SUBDIVISION REVIEW SHEET

CASE NO.: C8-2021-0078

SUBDIVISION NAME: Cearley Community Subdivision Preliminary Plan

**CITY OF AUSTIN –DEVELOPMENT SERVICES DEPARTMENT
SUBDIVISION APPLICATION – MASTER COMMENT REPORT**

SCALE	0		
DR.	CM	CH.	XG
P.M.	CJO		
BOOK	-		
JOB	20003191		
SHEET NO.	4 OF 12

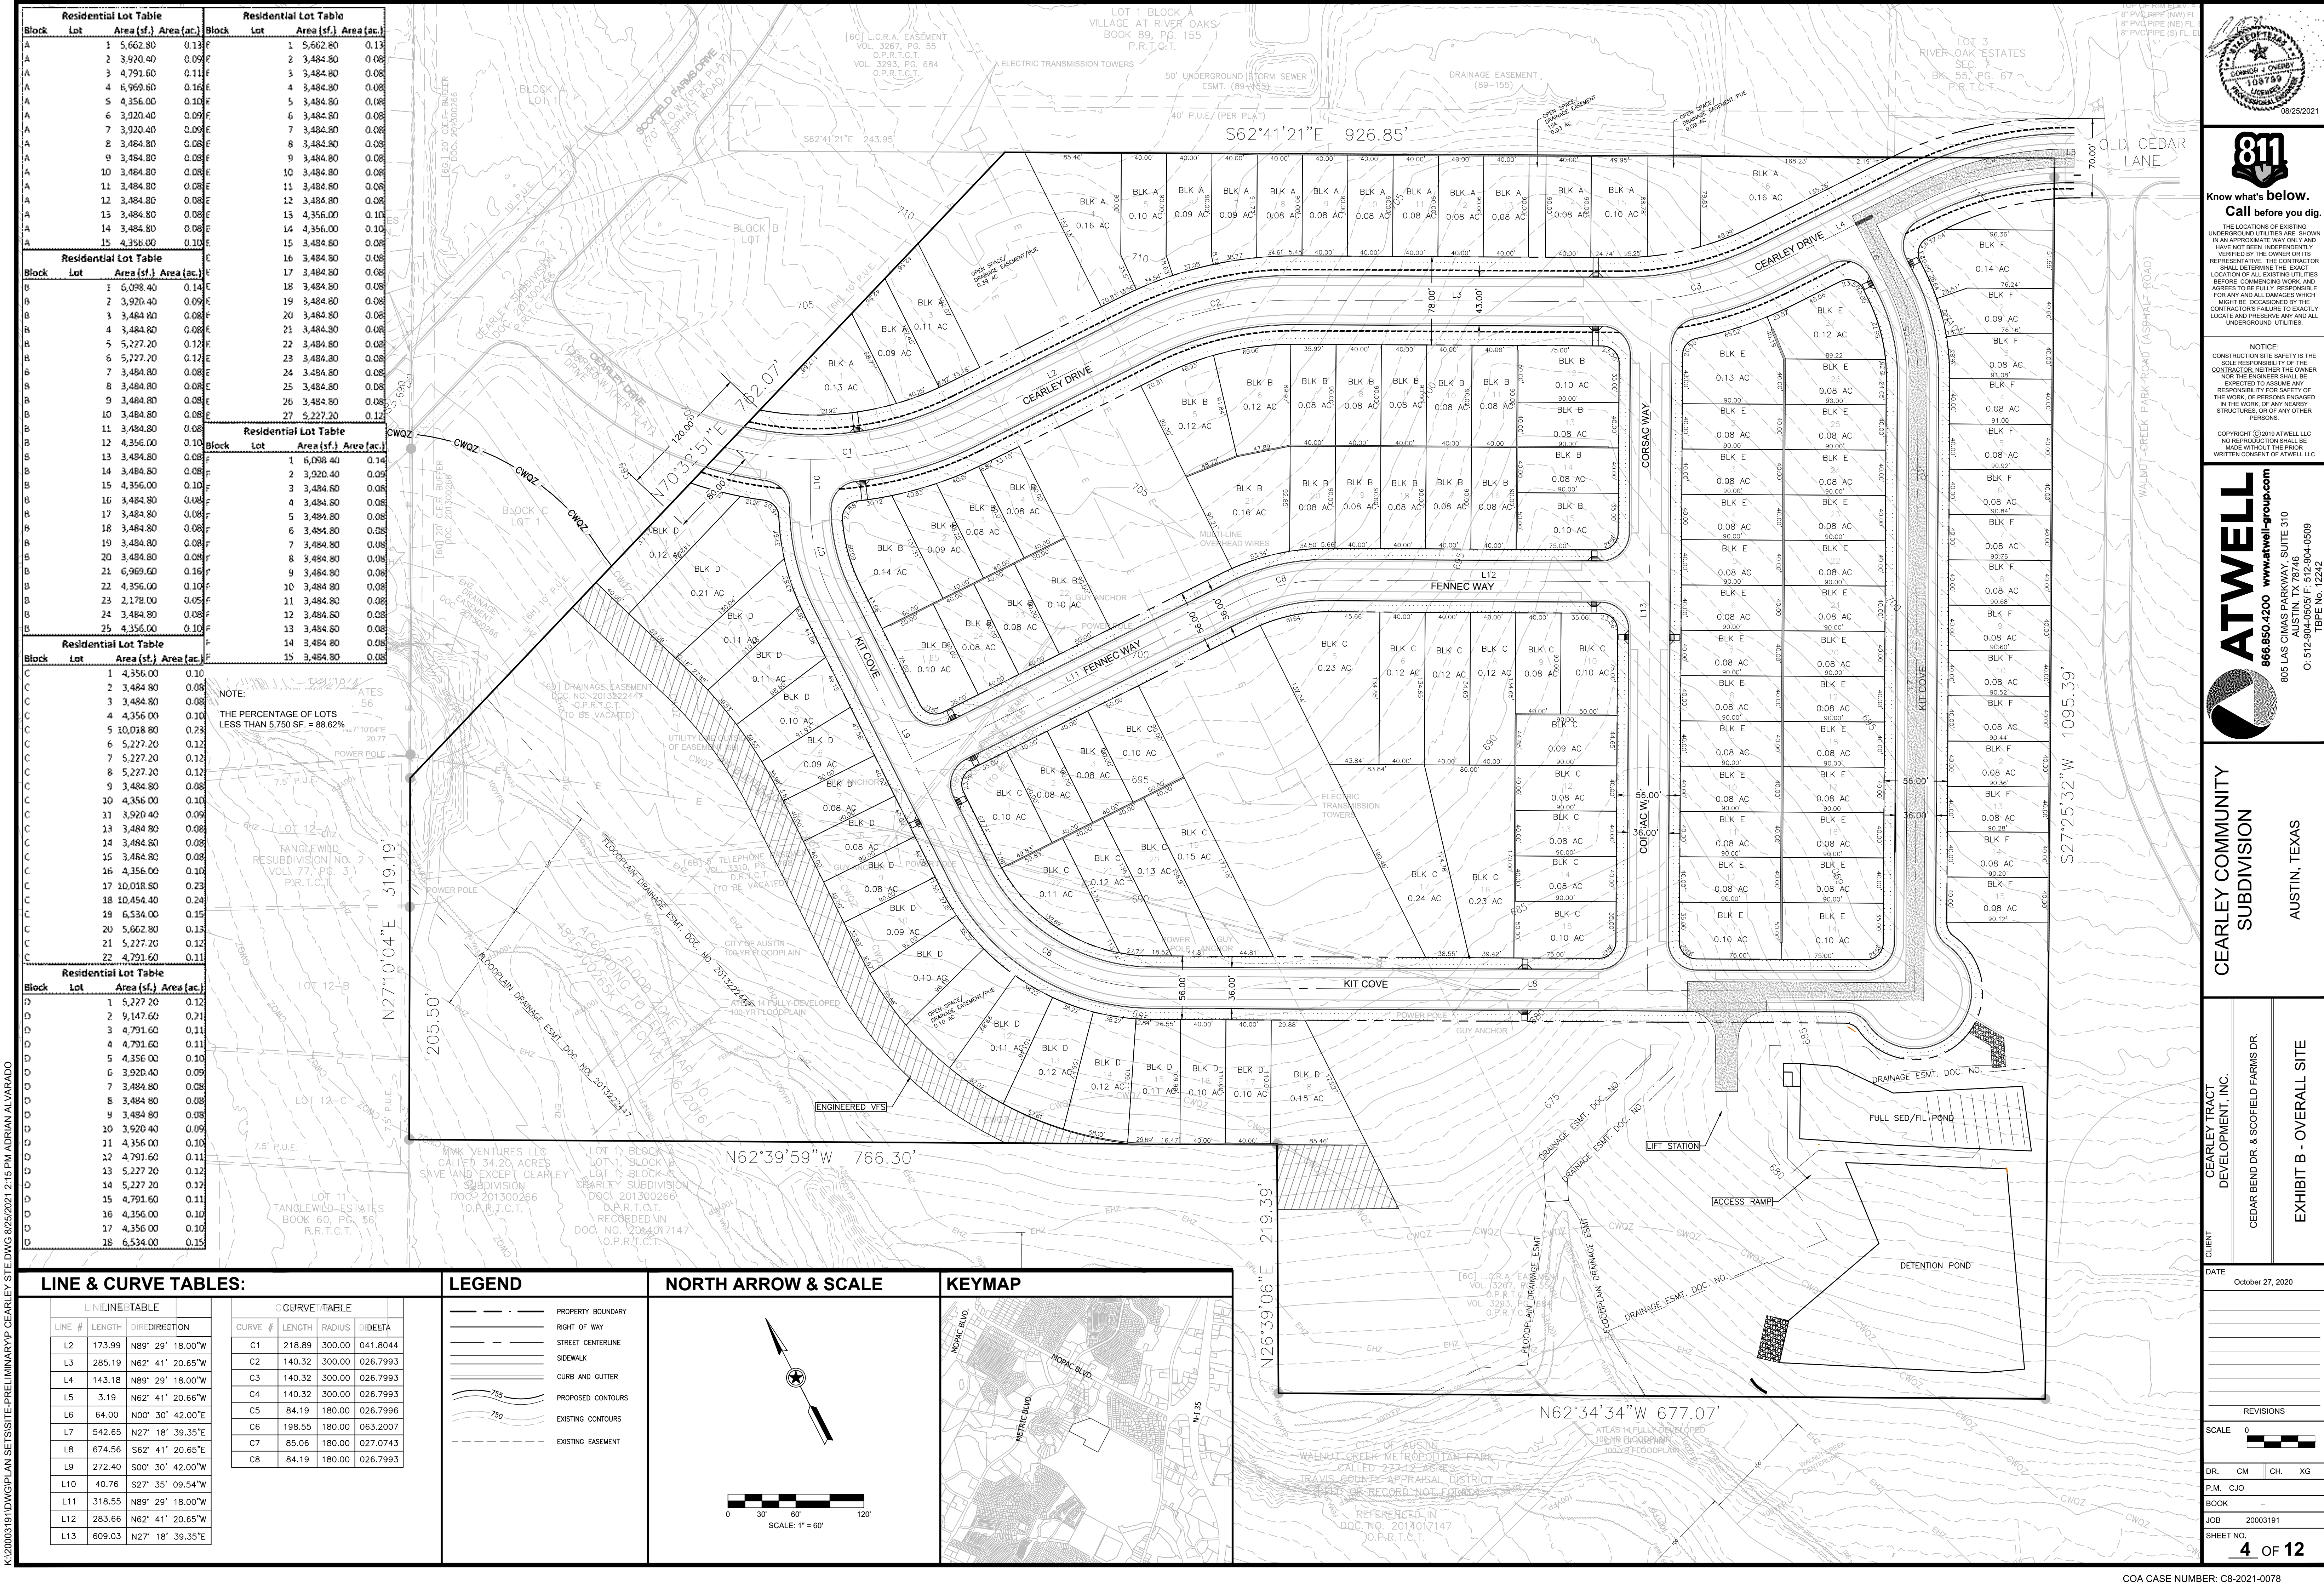
EC 1. If a curb inlet is present there shall be ten (10) feet between the inlet opening and the edge of a driveway curb return. [TCM 5.3.1a]. Provide a driveway exhibit showing compliance with TCM 5.3.1a. for the following lots:

Ten foot electric distribution, electric telecommunications, and electric fiber easement is required adjacent to all street R.O.W. Show the easement(s) on the face of the plat.

- ATD 7. A lot that is less than 50 feet wide and that fronts on a collector street must have a paved alley or paved private access easement along the rear property line. LDC 25-4-232 (C)(18). This applies to the several lots along CEARLY DRIVE. Please revise to meet this code requirement.

- 1) Label the existing CWQZ as "ORIGINAL CWQZ";
 - 2) Label the proposed buffer averaged CWQZ as "AVERAGED CWQZ";
- Also, show the 100-foot CWQZ minimum setback.

EV 5 Please explain the discrepancy between the slopes shown on the slope map, sh. 5, and those shown on Property Profile for the same location (orange = slopes >15%).

- CA1 Confirm no Heritage trees will be required to be removed with the design of this preliminary plan. The grading plans indicate grading within the CRZ of various Heritage trees.

- CA2 Removal of heritage trees is not allowed by code. Demonstrate compliance with LDC 25-8-641. Provide conceptual buildability exhibits for all lots with protected trees. Include existing regulated trees shown with conceptual footprints, driveway, and all utilities required to serve each lot.

- PR2. Show area to be dedicated, to include the southwest (creek and creek buffer), and south (west of detention pond and lift station) portion of the site, and may include drainage easements. Break out as individual lots, which should total at least 15% of the site. Label as "Park."
